June 16, 2022: Responses to PSC's unresolved comments dated May 4, 2022. For reference, PSC's unresolved comments are provided in red.

**Re: 518 and 540 South Avenue Comprehensive Permit
Response to Comments**

On behalf of Hanover R.S. Limited Partnership, Tetra Tech (Tt) has prepared the following responses to Civil Engineer comments raised during the May 10, 2022 public hearing by the Board's Peer Review Consultant, PSC and Chessia Consulting Services.

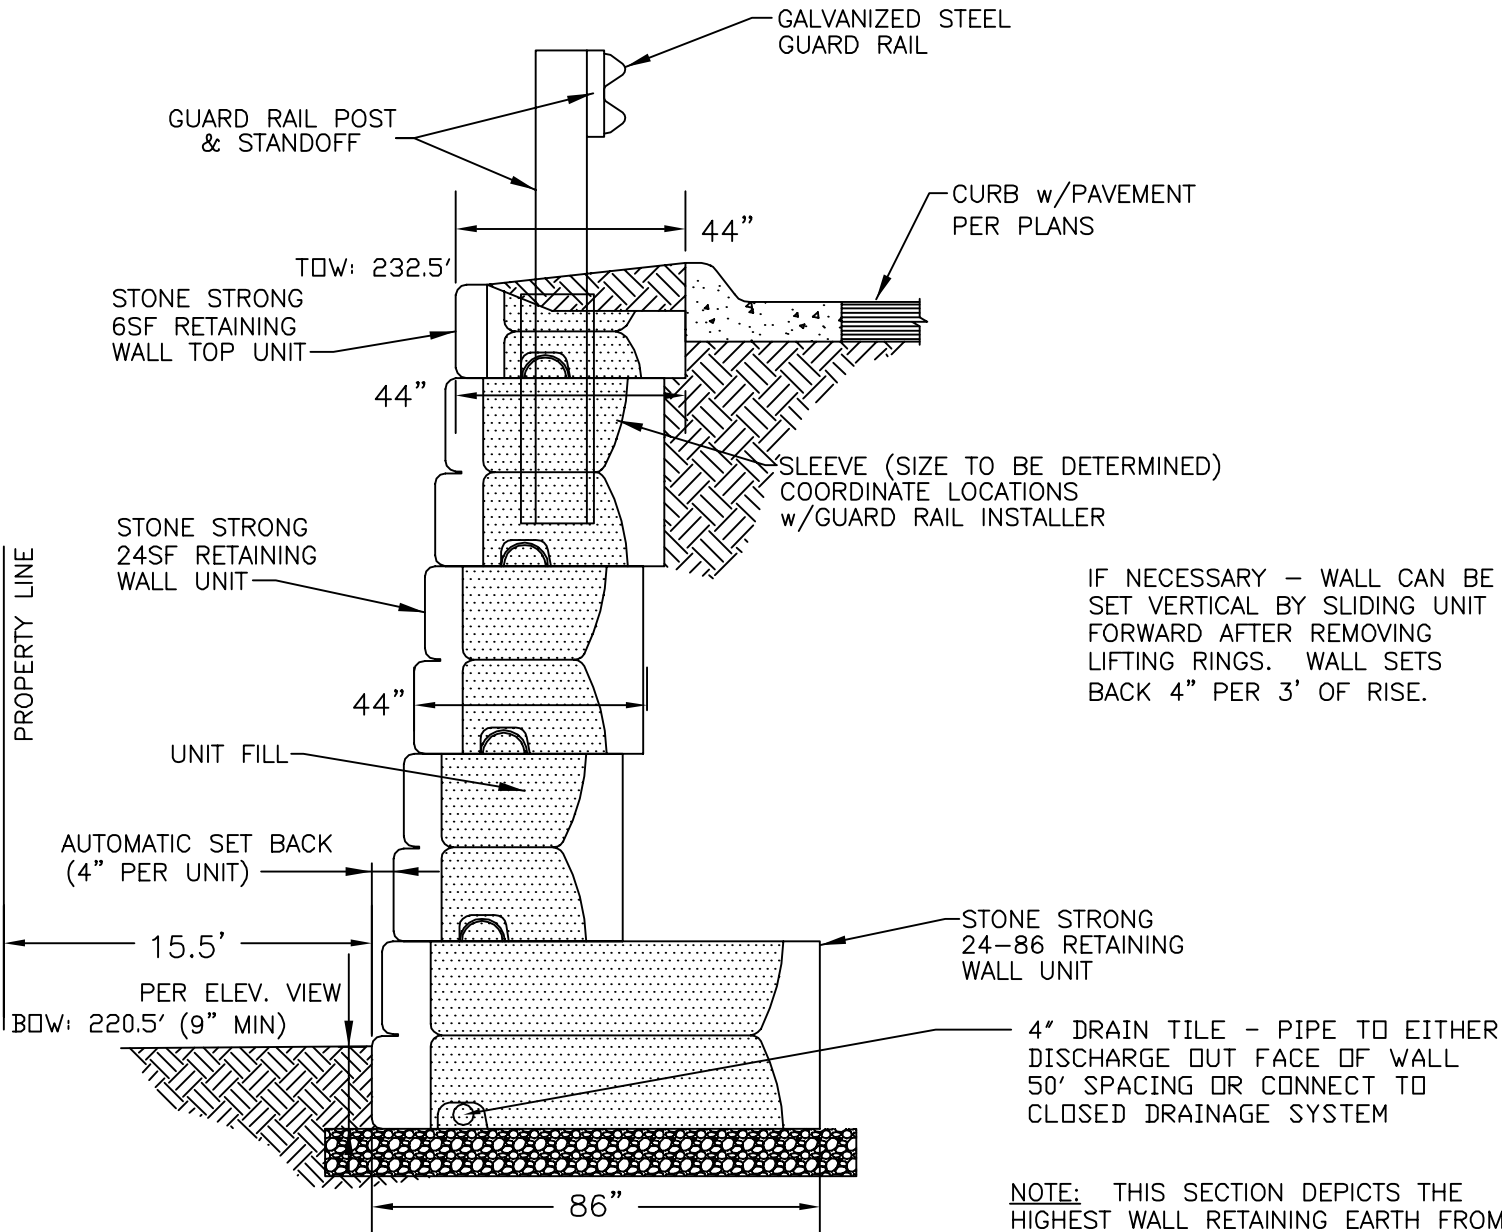
PSC 66	The proposed retaining walls need to be designed by a Massachusetts registered Structural Engineer. Calculations for factor of safety against overturning, sliding and bearing capacity are required for any section over 4-feet in height, and the proximity of wetlands and conditions of high groundwater and groundwater mounding should be factored into the design. If the structural plans are provided by a wall manufacturer, then the Board should require that the plans be based on site specific geotechnical information and they should not accept plans that are qualified by requiring further determination of geotechnical conditions after issuance of the signed and sealed structural drawings.	Tetra Tech	Tetra Tech has been coordinating with MBO Precast, the local representative for Stone Strong Retaining Walls. MBO Precast has reviewed the site retaining walls with their designer, Civil Connection. Civil Connection has developed three retaining wall sections to demonstrate wall constructability. A section has been cut near the northeast corner of the building, in the largest fill area. A section has also been cut at the southwest corner of the building, in the largest cut. Finally, a section has been cut adjacent to the porous pavement. As shown in the sections, all walls can be constructed as gravity walls, without the need for reinforcing. <small>The revised plans do not demonstrate feasibility of wall construction, e.g., feasible setback from the 25-ft no touch zone on east side, from sections of porous pavement, and from property lines. Also, wall Sections SK1, SK2 and SK3 included with the response matrix are not shown on details Sheet C-14. Details should dimension proposed wall and block heights and depths (face to back) and all dimensions from the aforementioned features. Also, provide a detail of fence installation at the walls.</small> Please refer to Tetra Tech's May 18, 2022 discussion on "Retaining Walls".

Retaining Walls: Retaining walls near the perimeter of the property are fundamental to the project design and will not be eliminated, reduced in height, or relocated. Adequate design detail, sufficient to prove the feasibility of the wall construction, has been provided during the ZBA process, including updated key retaining wall sections with dimensions of wall blocks, offsets to property lines and pavement. A fully engineered design will follow during the building permit process. Most of the walls will not be visible from neighboring properties. The applicant is willing to provide landscape screening on abutting properties for those abutters concerned about the visual aesthetics of the wall. However, the regional need for affordable housing outweighs any local concern over the visibility of retaining walls. Finally, the groundwater mounds developed under wastewater and stormwater disposal areas do not intrude into the wall footings, so they do not impact the structural stability of the walls.

NOTE: THIS SECTION DEPICTS THE HIGHEST WALL RETAINING EARTH FROM OFFSITE. THE MINIMUM DIMENSION REQUIRED TO INSTALL THE WALL BETWEEN POROUS PAVEMENT AND THE PROPERTY LINE IS 5 FEET. AT THE CLOSEST POINT, THE POROUS PAVEMENT IS SET 6.5 FEET FROM THE PROPERTY LINE.

GRAVITY SECTION WITHIN FILL AREA W/GUARDRAIL POST	CIVIL CONNECTION, LLC 38 EDWARDS DRIVE GILMANTON IW, NEW HAMPSHIRE 03837 TEL. (603) 393-9842	
	HANOVER PROJECT WESTON, MASSACHUSETTS	Drawn By: reb Checked By: reb File Name: c:richard Sections.hanover
Figure No. SK2

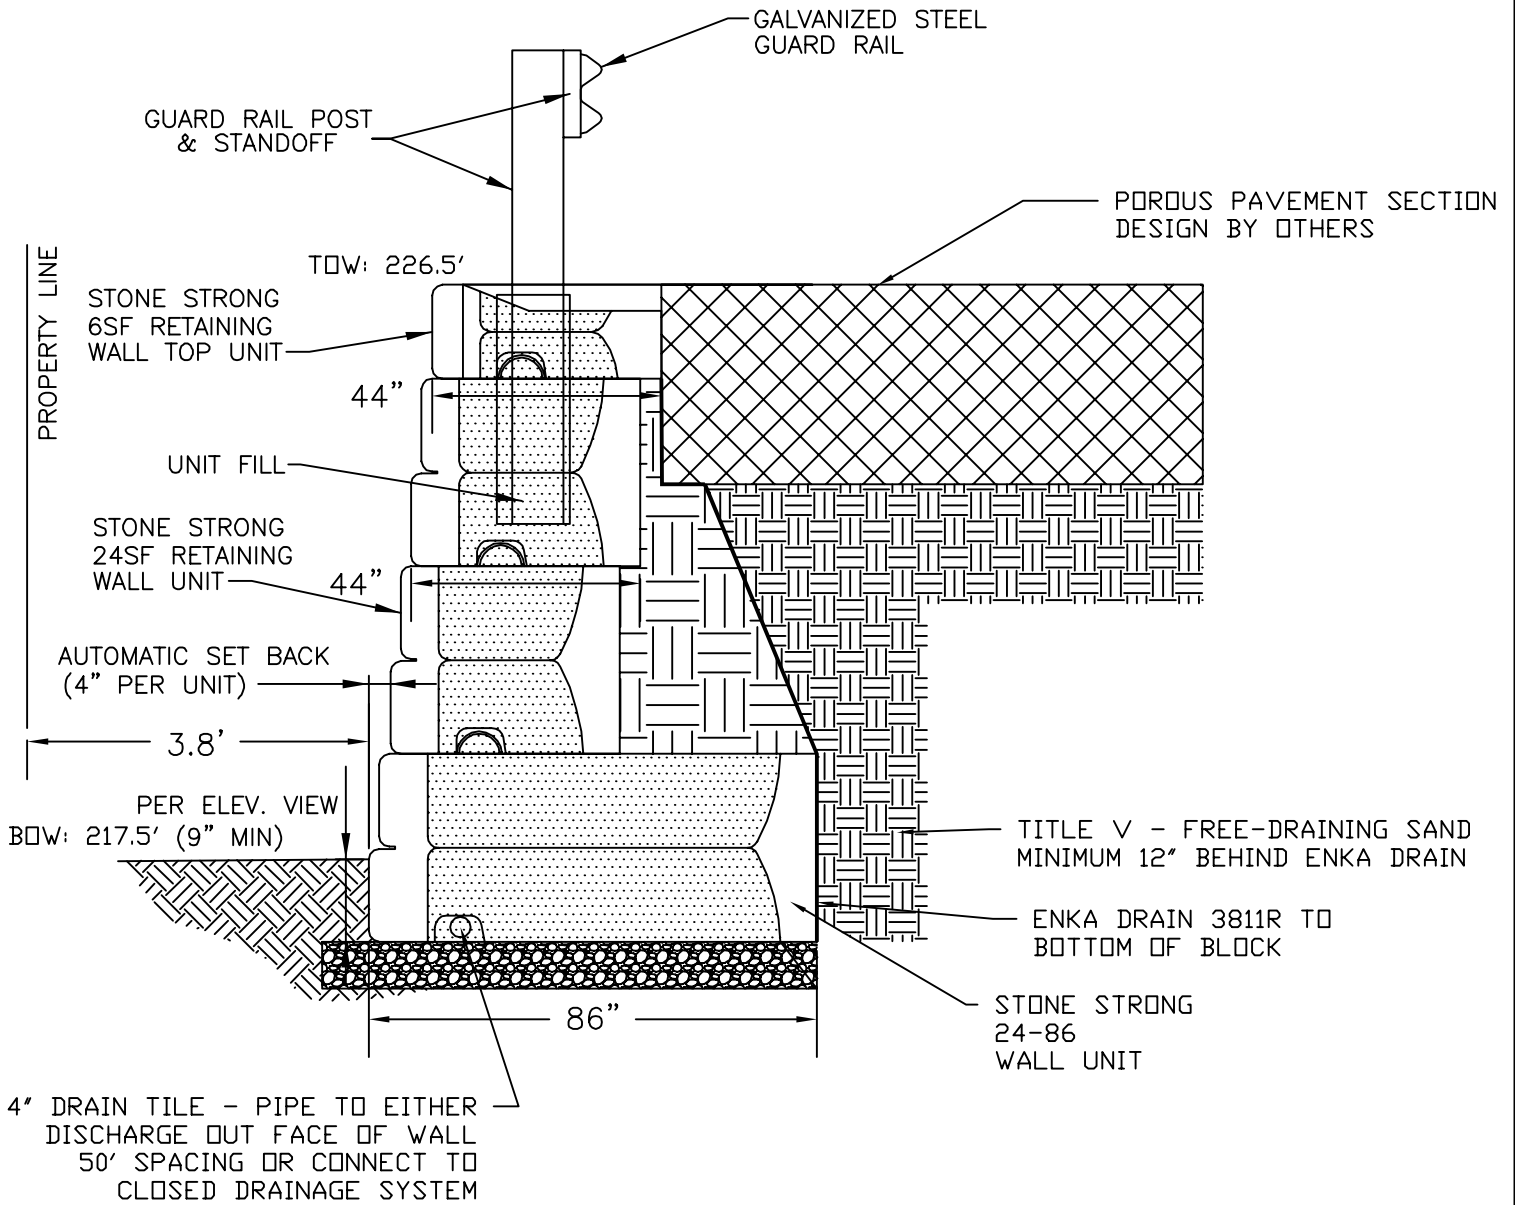
PSC 67	Provide a detail showing guardrail installation for retaining walls capable of resisting horizontal impact loads.	Tetra Tech	These are details that will be developed as part of the retaining wall design and will be submitted with the Building Permit for the retaining walls. However, MBO Precast, the local Stone Strong Retaining Wall Representative, has provided 3 key retaining wall sections, developed by their design Engineer, Civil Connection. Two of the retaining wall sections include guardrails. The guard rail post will be sleeved through the hollow cores of the retain wall blocks. Please refer to SK1-3.
PSC 68	The Zoning Board of Appeals will have to determine the acceptability of these retaining walls from an aesthetic and zoning aspect, especially considering the walls as structures are not compliant with yard setbacks.	Tetra Tech	Relief from local zoning setbacks has been requested.

NOTE: THIS SECTION DEPICTS THE HIGHEST WALL RETAINING EARTH FROM ONSITE. THE MINIMUM DIMENSION REQUIRED BETWEEN THE FACE OF WALL AND THE PROPERTY LINE IS 1’.
